**SUBJECT** : **Position lighting system with protective tape in the lens – minimum intensities**

**REQUIREMENTS incl. Amdt.** : **CS 25.1389(b)(1)(2), 25.1391, 25.1393 at Amdt. 26**

**Equivalent Safety Finding to CS 25.1389(b)(1)(2), 25.1391 and 25.1393 at Amdt. 26**

Figure 1: Position lighting system intensity coverage in normal operation

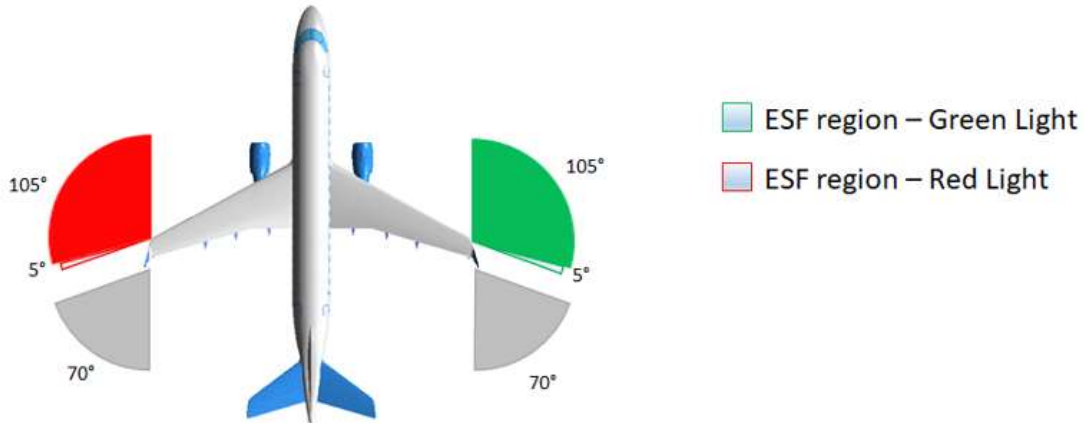
*“...depending on the operating mode, the red and green lights could not meet the minimum intensity requirements at the extreme dihedral angles of 105 to 110 degrees, and in the area of 5 to 10 degrees up azimuth. The intensities at all other angles are well above the requirements.”*

- Depending on the operating mode, the red and green lights of the position lighting system may be below the minimum intensity requirements at the extreme dihedral angles of 105 to 110 degrees, and in the area of 0 to 15 degrees up azimuth (see figure 1 in Appendix A).
- Only in the standby operating mode, the red light of the position lighting system may be below the minimum intensity requirements at the extreme dihedral angles of 15 to 20 degrees, and in the area of 0 to 5 degrees up azimuth (see figure 2 in Appendix A).

- a) The intensities at all other angles are well above the requirements.
- b) The shortcoming in the required intensity is less than one percent of the required area. It is compensated by the overall intensity provided over the rest of the coverage area. Moving up and down from the critical vertical angle at the same dihedral angle, the supplied light intensity is multiple times the minimum of the value required by the corresponding CS.
